CIBSE TM59: corrigenda

CIBSE: 6/06/17

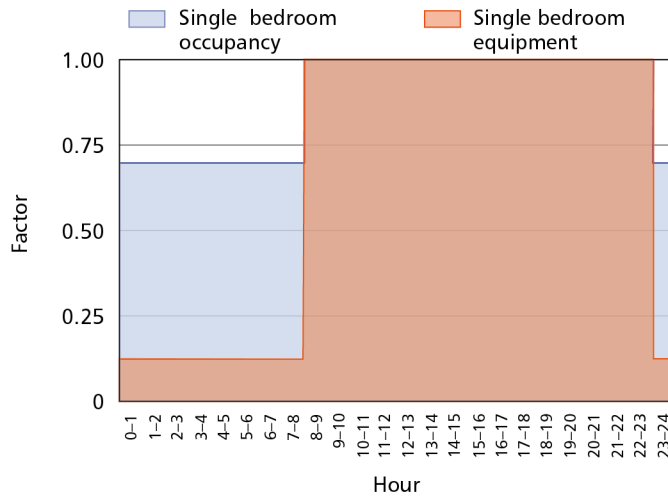
Page 8 Figure 1: Values for studio occupancy amended; corrected version attached.

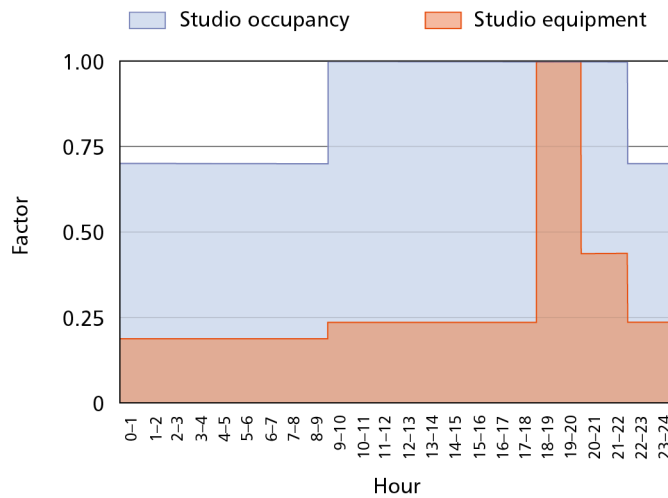
Page 8 Figure 2 amended: corrected version below.
